Project	<b>IEEE 802.16 Broadband Wireless Access Working Group</b> < <a href="http://ieee802.org/16">http://ieee802.org/16</a> >	
Title	<b>MS contention-based ranging and automatic adjustments with transparent RS attached to a superordinate nontransparent RS under centralized scheduling</b>	
Date Submitted	<b>2007-09-09</b>	
Source(s)	Kanchei (Ken) Loa, Yi-Hsueh Tsai, Yung-Ting Lee, Hua-Chiang Yin, Shiann-Tsong Sheu, Youn-Tai Lee	Voice: +886-2-27399616 Fax: +886-2-23782328 loa@iii.org.tw
	Institute for Information Industry 8F, No. 218, Sec. 2, Dunhua S. Rd., Taipei City 106, Taiwan	
	[add other co-authors here]	
Re:	IEEE 802.16j-07/043: "IEEE 802.16 Working Group Working Group Letter Ballot #28"	
Abstract	This contribution proposes MS contention-based ranging and automatic adjustments with transparent RS attached to a superordinate nontransparent RS under centralized scheduling	
Purpose	Text proposal for 802.16j Draft Document.

# MS contention-based ranging and automatic adjustments with transparent RS attached to a superordinate nontransparent RS under centralized scheduling

Figure 1 Current scenario

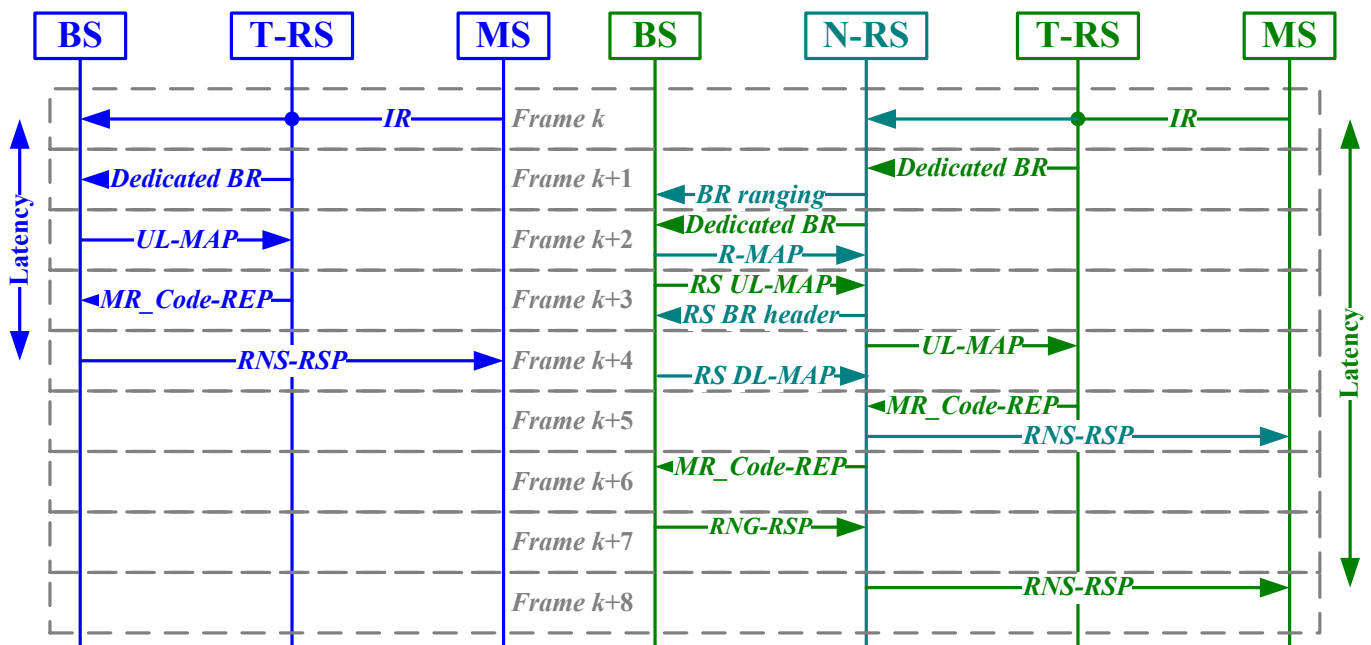
However, a subordinate transparent RS attached to a superordinate non-transparent RS under centralized scheduling cannot handle MS contention-based ranging and automatic adjustments. If the ranging code is received by both subordinate transparent RSs and superordinate non-transparent RS, the transparent RSs must request uplink bandwidth to send MR\_Code-REP message to MR-BS, whereas the non-transparent RS must request downlink bandwidth to broadcast RSG-RSP message to MSs. As a result, the MR-BS will compare measured signal information at each transparent RS to decide the most appropriate path to communicate with the code originating MS but will also allocate downlink bandwidth for non-transparent RS broadcasting RNG-RSP message. Hence, the decision at the MR-BS will be incorrect. (see Figure 1)

Figure 2 Proposed scenario

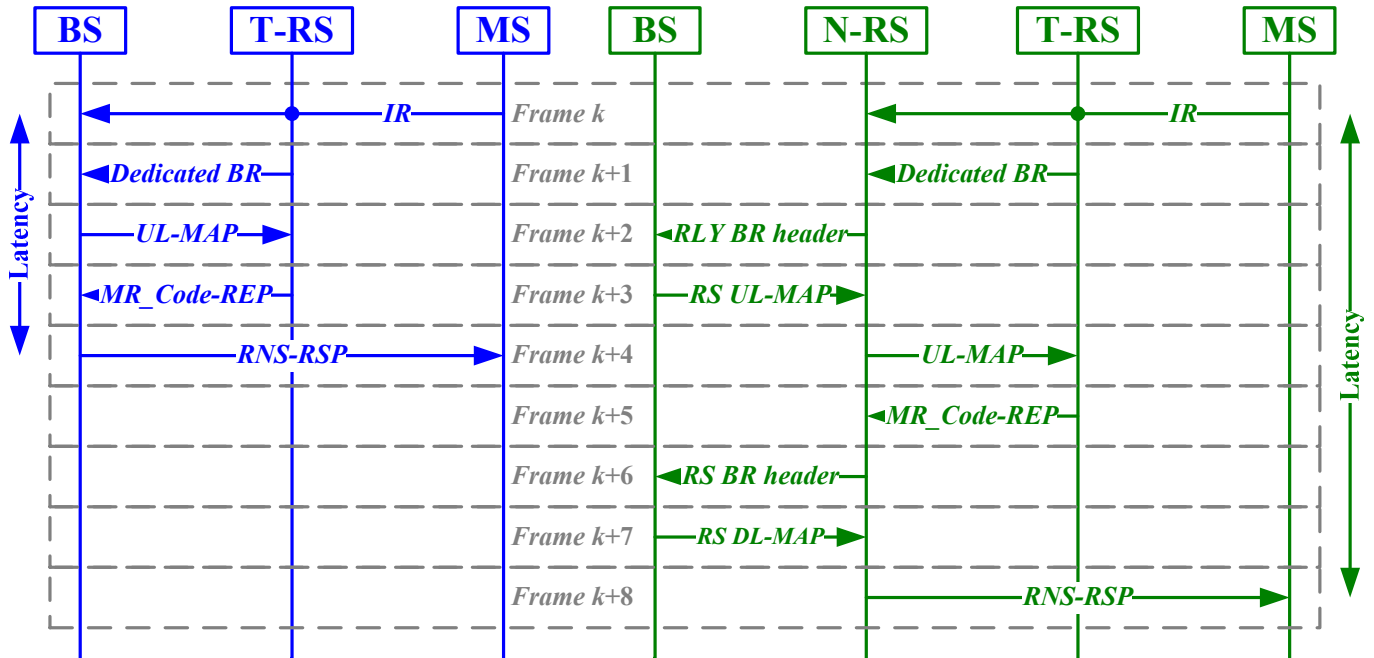
Therefore, we propose a solution described as follows (see Figure 2). If the ranging code is received by both subordinate transparent RSs and superordinate non-transparent RS, the transparent RSs must request uplink bandwidth to send MR\_Code-REP message to the non-transparent RS. As a result, the non-transparent RS will compare measured signal information at each transparent RS to decide the most appropriate path to communicate with the code originating MS. Then, the non-transparent RS must request downlink bandwidth for broadcasting RNG-RSP message.

Figure xxx-a—Handling CDMA ranging code at a subordinate transparent RS

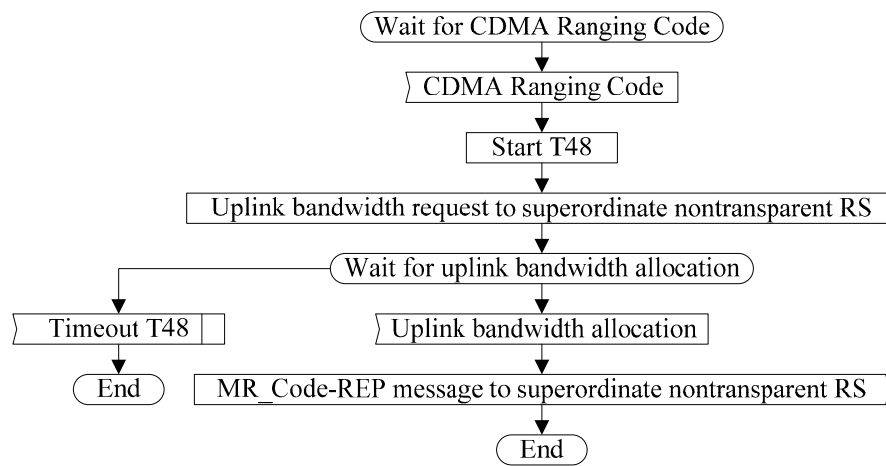
The message flow charts in Figures xxx-a, xxx-b describe the ranging and adjustment process that shall be followed by compliant RSs and MR-BSs.
